Service Technical Information

MODEL NO. AM-HX50 / HX55
SUBJECT Come off screw of HP JACK

REF.No. :G - A0 - 011 - E0

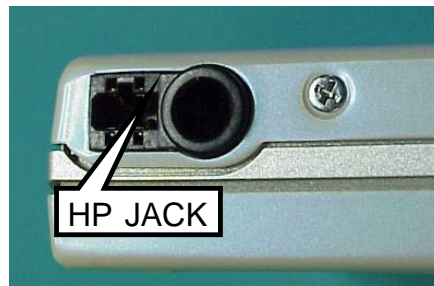
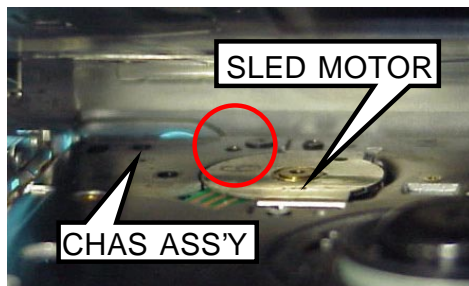
For the above mentioned products, the screw holding the HP JACK are occasionally lost. When this screw dislocate, it attach to the spindle motor or to the magnets of the PICK UP, causing possible NO PLAY. Complete the following procedures when the screw is missing. And also complete the following procedures when the screw is taking out during repair.

1. Don't fasten too tightly the screw to fix the HP JACK.
 - (1)Be sure that the screw don't protrude from the chassis.
 - (2)Be sure that stress is not applied to the HP JACK.

- 2.Don't get glue on the sled motor or gears.

Replace the screw holding the HP JACK with the Parts Code listed below and glue it on. Use glue No. 1600B(No.1620B).
